HARVEST VALLEY ESTATES

SEDGWICK COUNTY, KANSAS S.W. 1/4, SEC. 7, T 29 S, R 2 W

Re: S/D 97-41 -- Final Plat of HARVEST VALLEY ESTATES

Re: S/D 97-41 - Revised Preliminary Plat of HARVEST VALLEY ESTATES

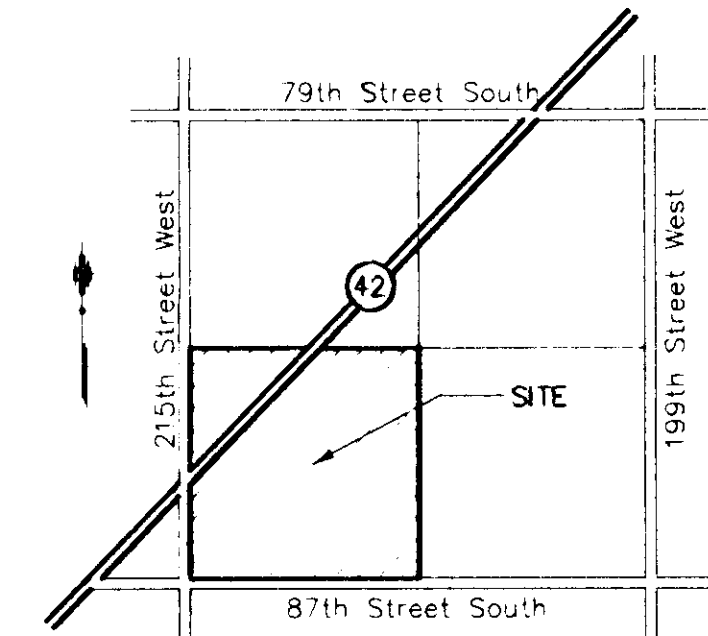
County Engineering has indicated the proposed intersections with K-42 are unacceptable. A revised street layout is needed which includes Festival Street as a cul-de-sac; a loop street combining Harvest Valley Drive, Amber Ridge and Shade Court; and a cul-de-sac replacing the current Harvest Valley Drive intersection with K-42.

For Lot 9, Block 1, 100 feet of complete access control shall be dedicated along the southern frontage of the lot along 215th Street West. For Lot 3, Block 2, complete access control shall be dedicated for the north 100 feet and the south 100 feet of frontage along 215th Street West.

County Engineering has commented that the drainage concept is acceptable. The drainage easements shall be shown on the final plat as a floodway reserve, and be a minimum width of 50 feet. The drainage easement on Lot 17, Block 2 shall be realigned to line up with the culvert under 87th Street South.

County Engineering has indicated the proposed intersections with K-42 are unacceptable. A revised street layout is needed which includes Festival Street as a cul-de-sac; a loop street combining Harvest Valley Drive, Amber Ridge and Shade Court; and a cul-de-sac replacing the current Harvest Valley Drive intersection with K-42.

The final plat includes the requested access controls. However, Lot 3, Block 2, located on the southwest corner of the plat, now denotes access to 87th Street

South, rather than 215th Street West as indicated on the preliminary plan.

The final plat includes the requested revisions by County Engineering. On the final plat tracing, the centerline of the floodway reserves should be denoted by a dashed line. The platting text should note the creation of the Floodway reserves. County Engineering needs to comment on the status of the applicant's drainage plan. The drainage plan has been approved although revisions need to be made to minimum building pad elevations. County Engineering also requires a letter of map revision regarding the floodway located within the plat.

The final plat includes a revised street layout as requested by County Engineering.
